CR 19 (Slate Quarry Rd) Safety Assessment

NYS Route 9G to White Schoolhouse Rd, Town of Rhinebeck

Poughkeepsie-Dutchess County Transportation Council

Figure 12. The steep pavement edges make it difficult to walk or bike along Slate Quarry Rd.

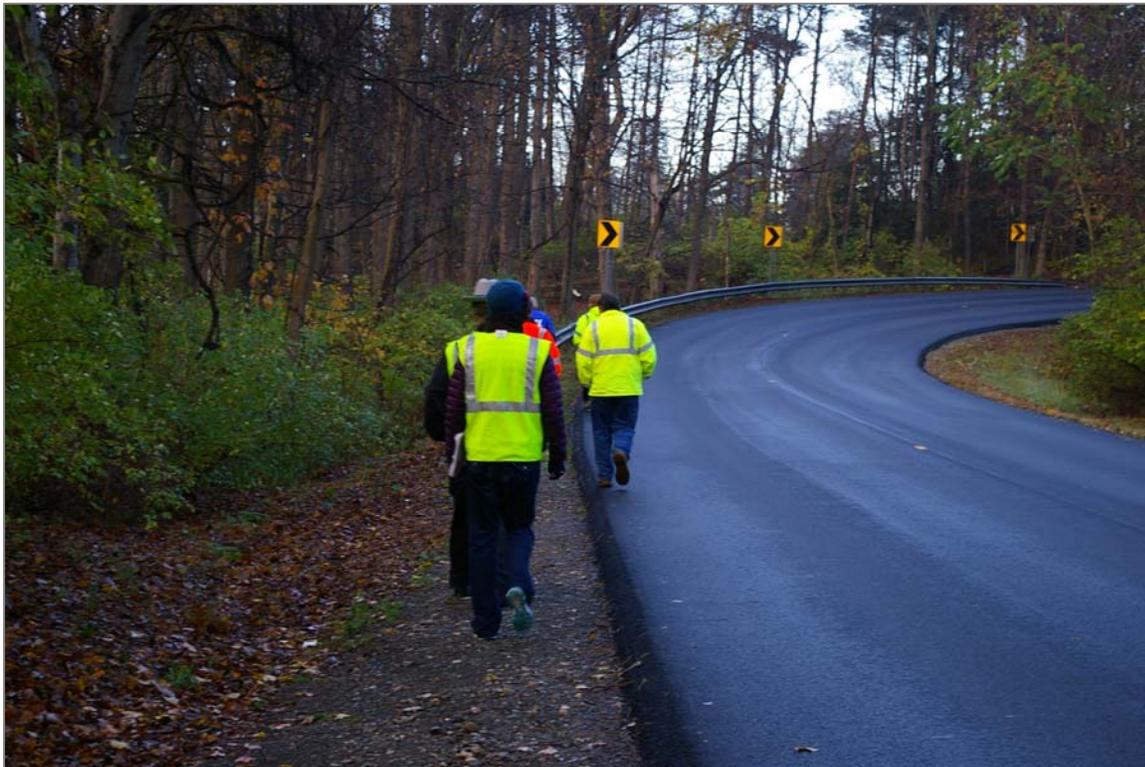
Safety Concern: The newly paved road contains significant shoulder (pavement edge) drop-offs throughout the study area.

Observations: Given that travel lanes will be 11 feet wide, the resulting paved shoulders will vary from 2 to 3 feet in width, with an additional 2 to 4 feet of unpaved shoulder. In many cases, these paved shoulders drop off substantially at the edge and thus represent a hazard to all users, including those walking and biking along the road. DCDPW indicated that these shoulder drop-offs would be backfilled, and that pavement at entrances to the residential driveways would be blended with the new pavement height to remove any abrupt dips. See Figures 11-12.

Risk Analysis: Steep edge drop-offs can cause loss of control when a vehicle drifts towards the shoulder. If a driver attempts a sudden correction to regain control, the vehicle can become destabilized, resulting in a crash. The lack of adequate clear areas and relatively high operating speeds along the road increase the chances of a severe crash.

1. Reduce shoulder drop-offs by installing shoulder backup material. The material should be compacted and designed to limit future erosion. Compacted sub-base material treated with *alignosulfonate* (natural wood polymer acting as a binder) is one possibility.
2. Consider adding a safety wedge, which allows drivers who drift off the road to return to the road safely. Instead of a vertical drop-off, the Safety Edge shapes the edge of the pavement to 30 degrees. FHWA-supported research has shown that this is the optimal angle to allow drivers to re-enter the roadway safely.
